<b>Dwelling type:</b>	Double Storey
<b>Dwelling configuration:</b>	House and Garage
<b>Nature of works:</b>	New Build
<b>Stage of inspection:</b>	Fixing & Waterproofing
<b>Construction Type:</b>	Multiple Claddings
<b>Garage:</b>	Attached
<b>Foundations:</b>	Waffle Slab
<b>Builder:</b>

### **Defects, observations and other related comments from Fixing & Waterproofing Inspection on 13/12/2023.**

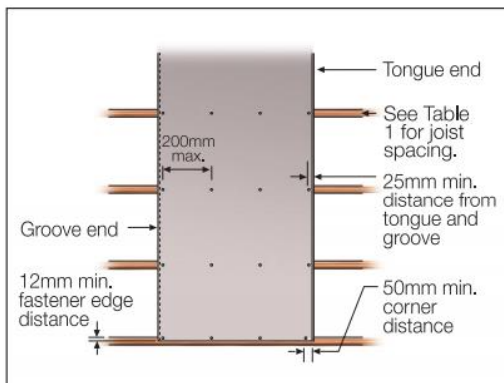
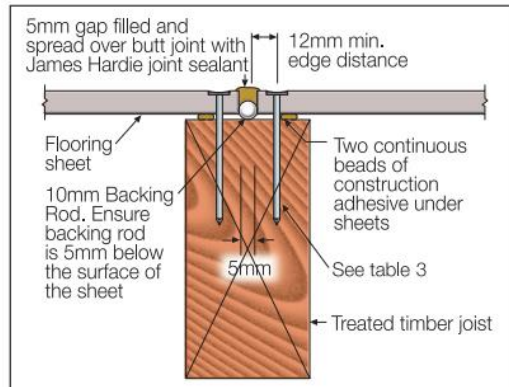
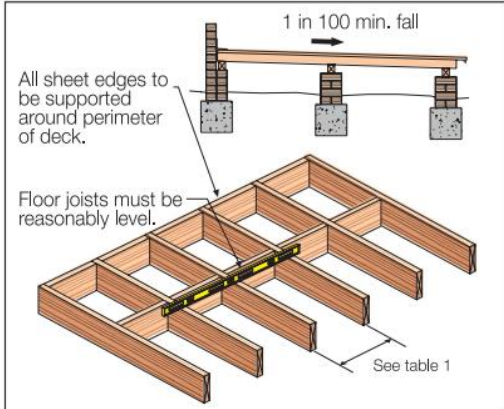
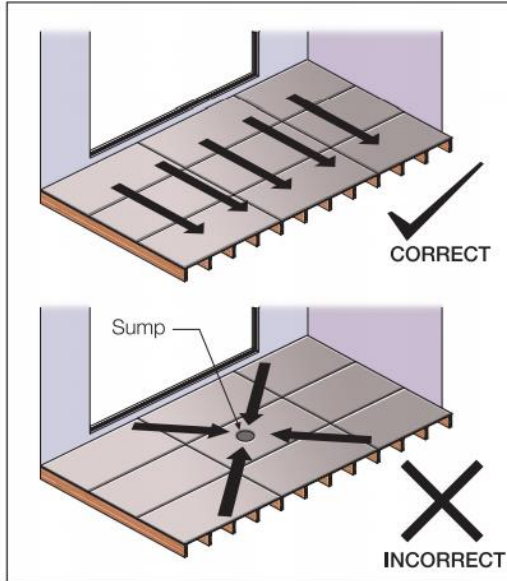
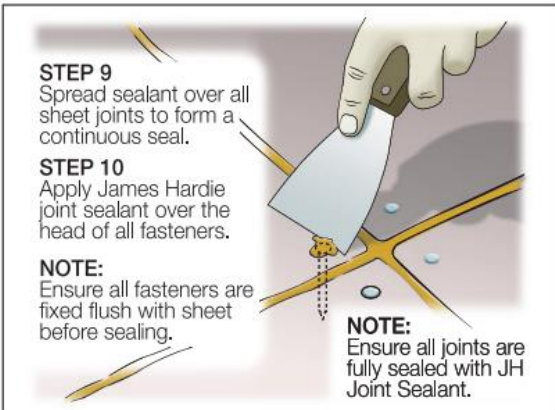
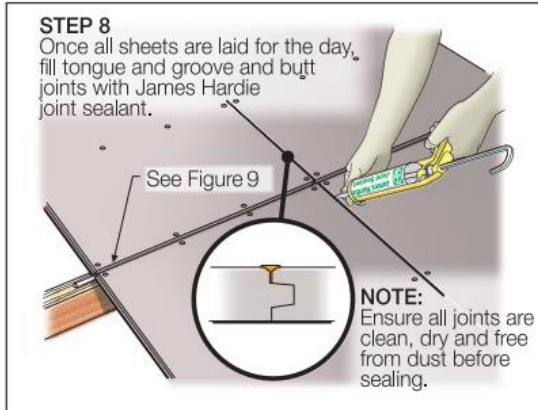
**James Hardies Scyon Secura External Flooring Installation Guide:** - The Scyon Secura External sheet flooring has not been installed as per the following manufacturer's instructions:

- Nail spacing is greater than 200mm max. centres
- Joints have not been sealed
- Butt joints less than the required 5mm
- Fastener heads not sealed
- Fixings closer than the minimum 25mm from tongue and groove edges
- Fixings closer than the minimum 12mm from butt joints

Dwellings flooring installation has not been completed as per manufacturers installation guide.

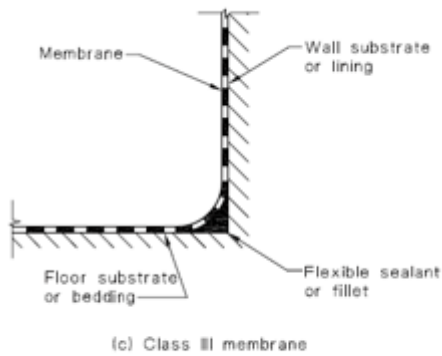
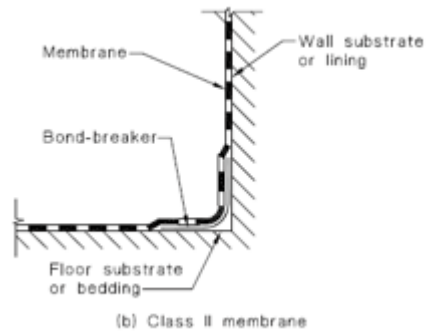
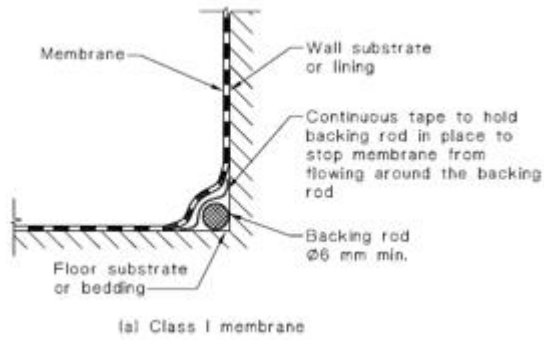
**AS 3740; 3.13.7:** - Bond breakers shall be included at all wall/floor, hob/wall junctions and at movement joints where the membrane is bonded to the substrate as per Table 3.2.

This installation has not met this requirement.

All areas to comply

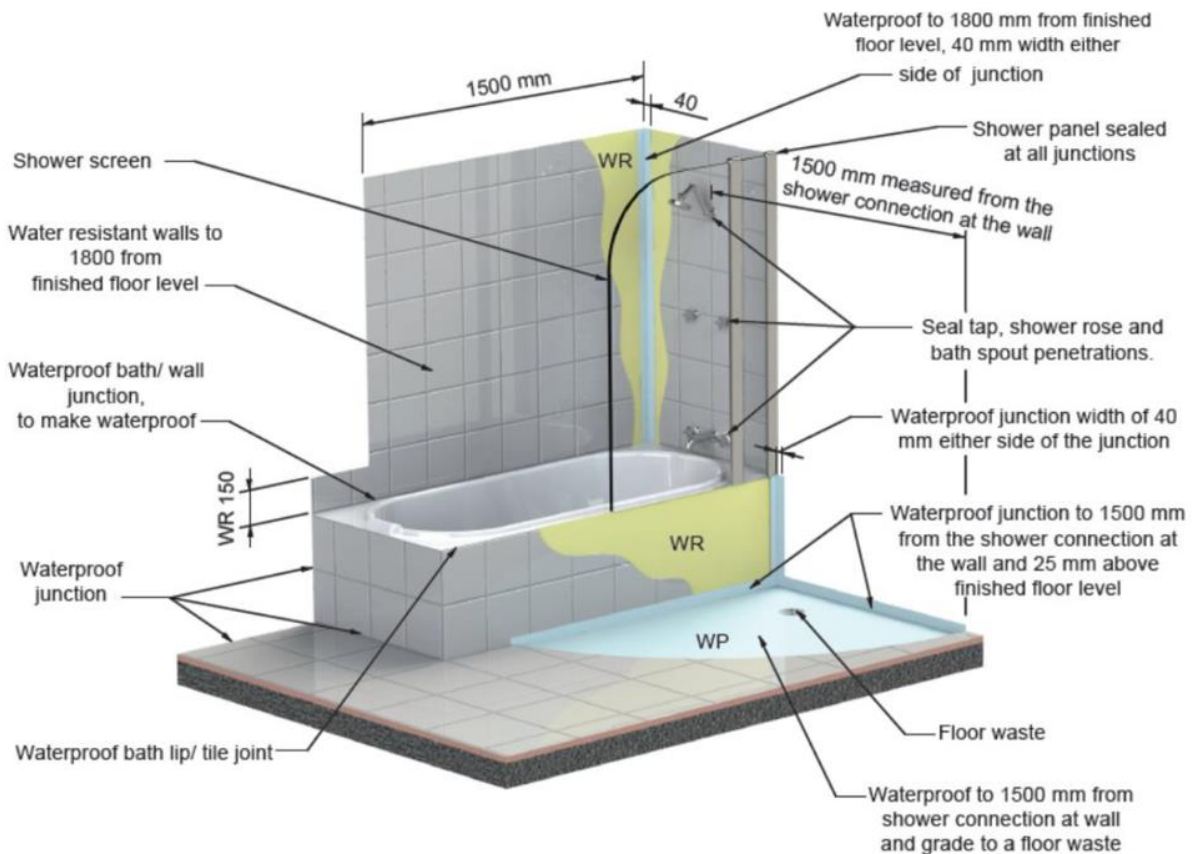
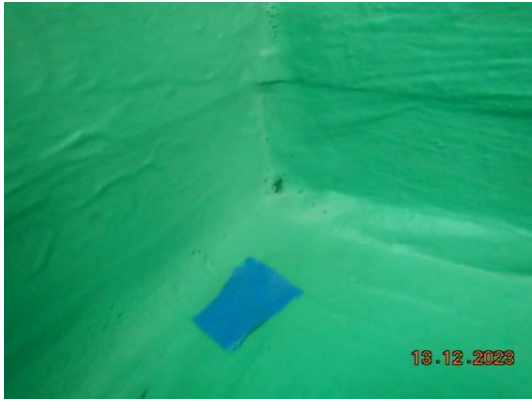
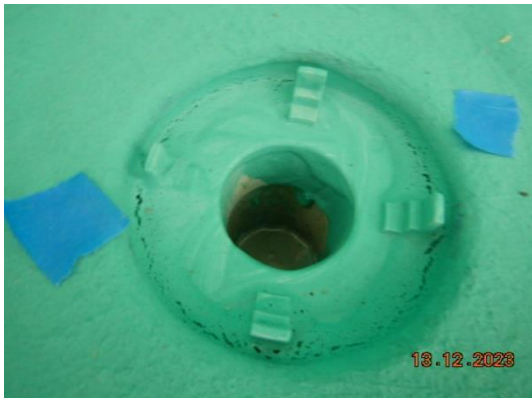
We noted some small holes, cracks, or gaps in various sections to the membrane in wet areas.

Small holes in membrane

All areas must be **waterproof** in accordance with the NCC Volume 2 and the manufactures specifications.
